National Pollutant Discharge Elimination System

Fact Sheet for

St. Joseph Energy Center

October 2013

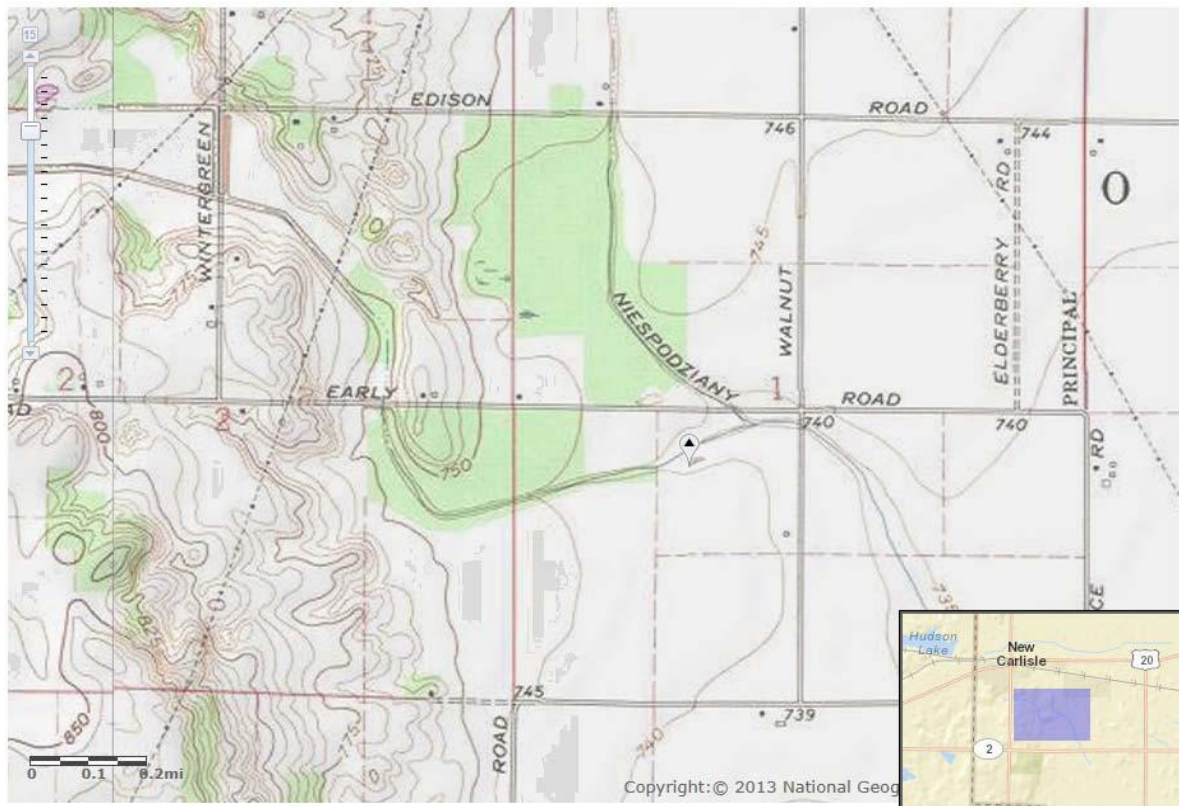
Comment 6: The ADD references biological and chemical data generated by IDEM on the Niespodziany Ditch watershed, specifically a study conducted by IDEM on the Laskowski Ditch. The ADD states that the Laskowski Ditch is a tributary to the Niespodziany Ditch; however, the ditch shown in Attachment 3 is actually the Hooten Ditch and not the Laskowski Ditch. The Laskowski Ditch does not intersect with Niespodziany Ditch and is located in a separate drainage area to the east. Is the chemical and biological data referenced in Attachment 4 acceptable for documenting the biological and chemical conditions of the receiving waters?

Response 6: The comment is correct as data provided for what was called “Laskowski Ditch” is representative of what is actually named “Hooten Ditch”. Based on information provided by IDEM, the waterbody name was “tributary to Niespodziany Ditch” and the HUC name was called “Laskowski Ditch-Kankakee River”. After further review, SJEC has confirmed the correct name of the sample location is indeed Hooten Ditch. In any case, data collected from such ditch sample location, IDEM location ID,UMK010-0029 at latitude 41.68556408 and longitude -86.48083052 (see below), is representative of the Hooten Ditch and the conclusions presented in the ADD remain unchanged.
